## ADDENDUM

**ADDENDUM NO.:** 03

**PROJECT NAME:** Lake View High School Renovation Project

**DATE OF ISSUE:** May 1, 2017

**A8.3**

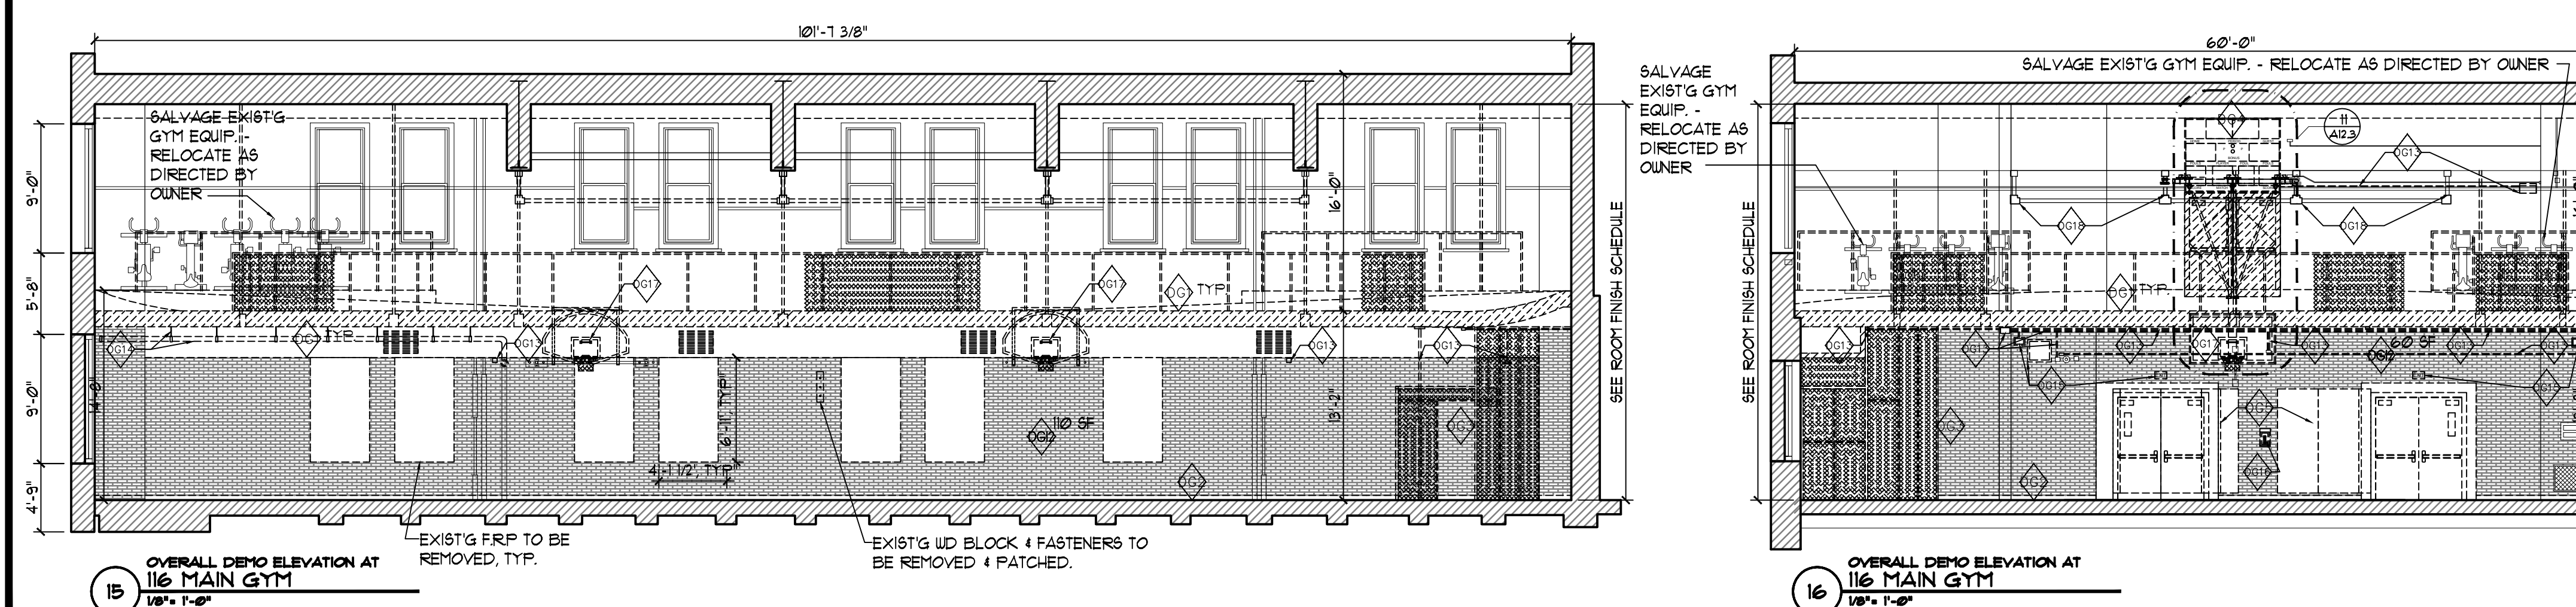
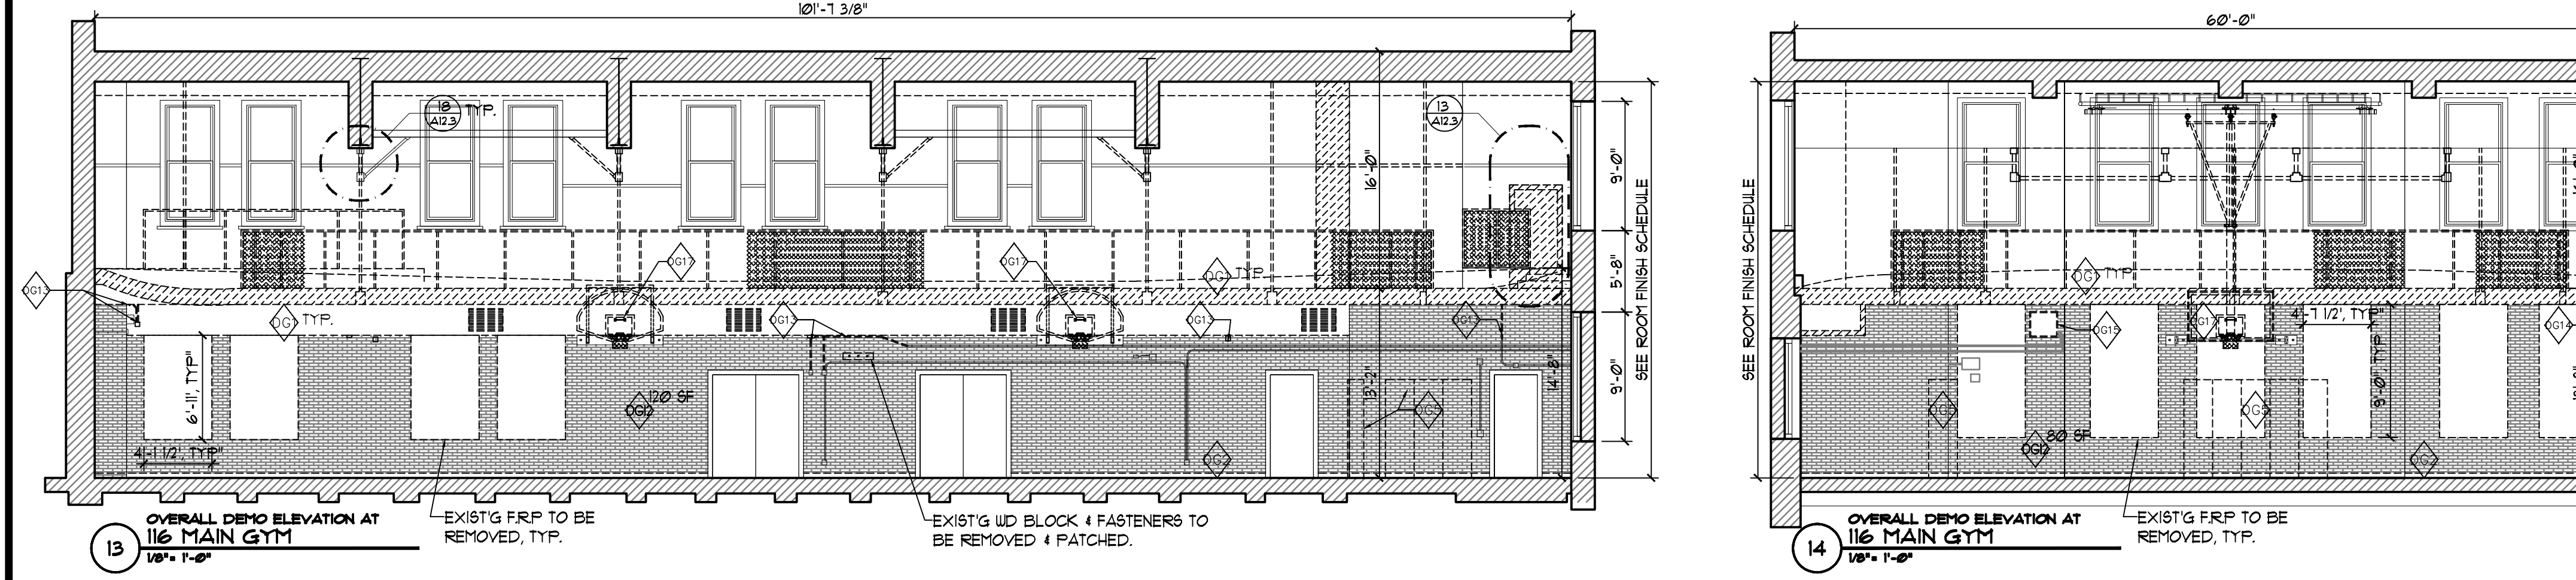
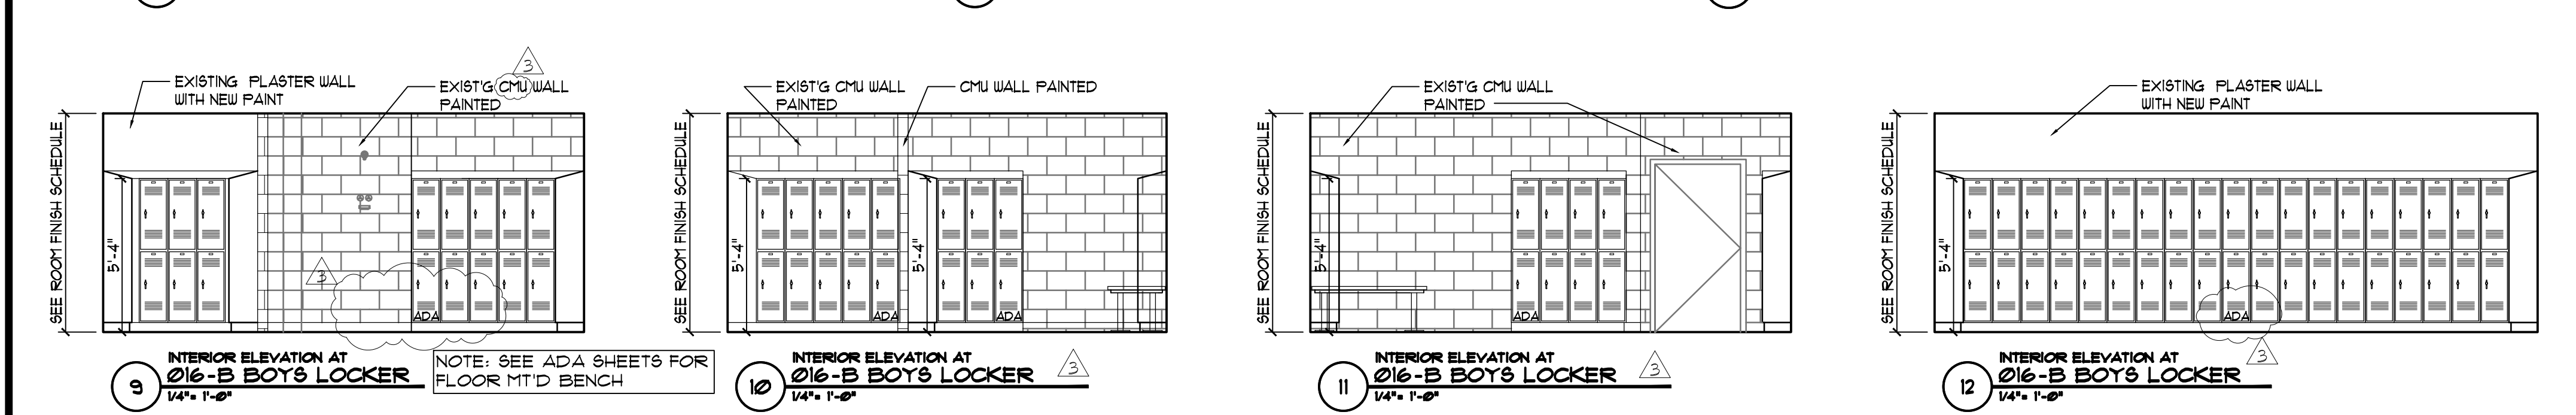
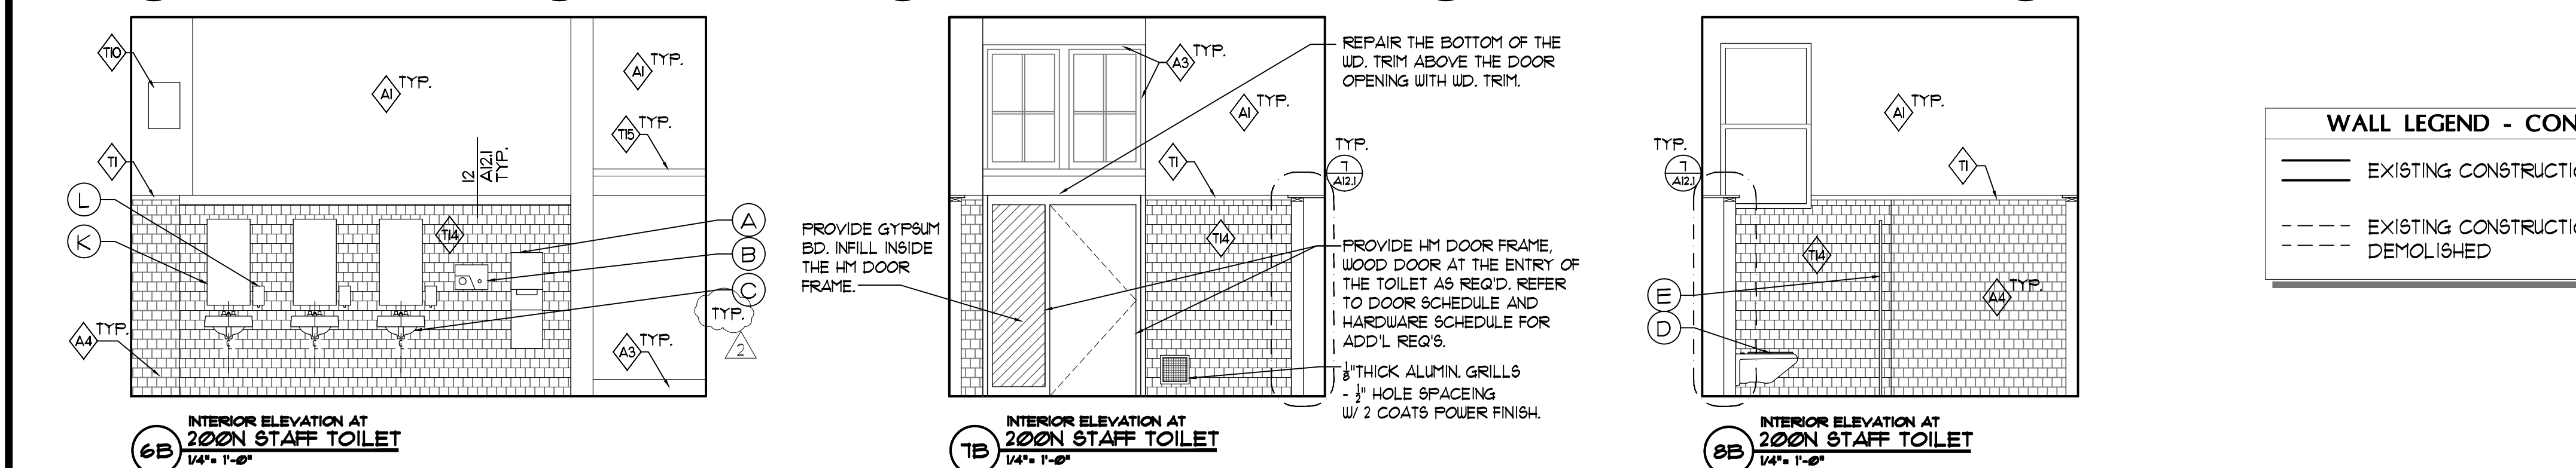
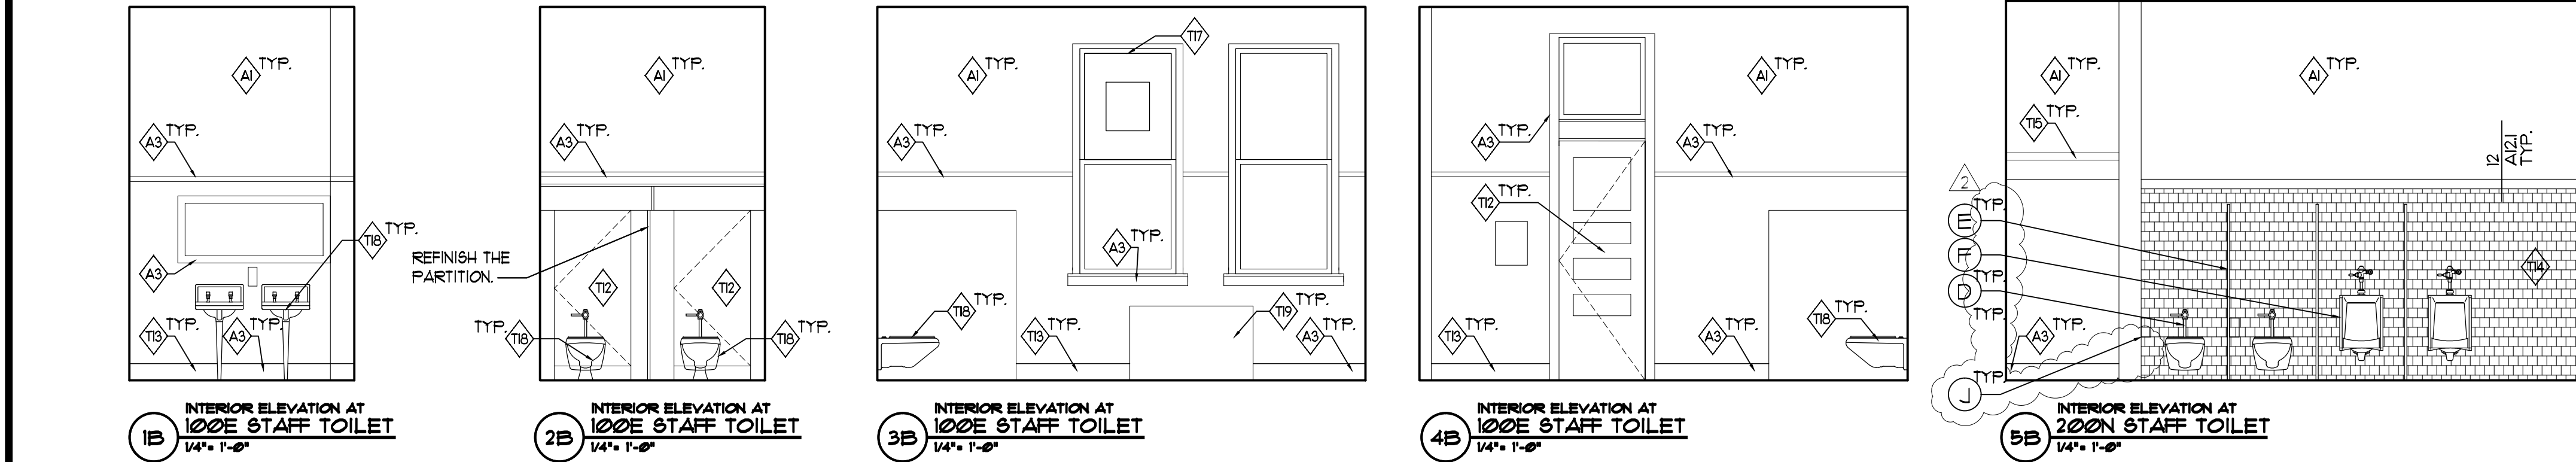
- REVISED** Drawing No. 8.3, ENLARGED FLOOR PLANS – Detail #5 revised to illustrate updated locker and ADA bench configuration in Boys Locker #016-B.
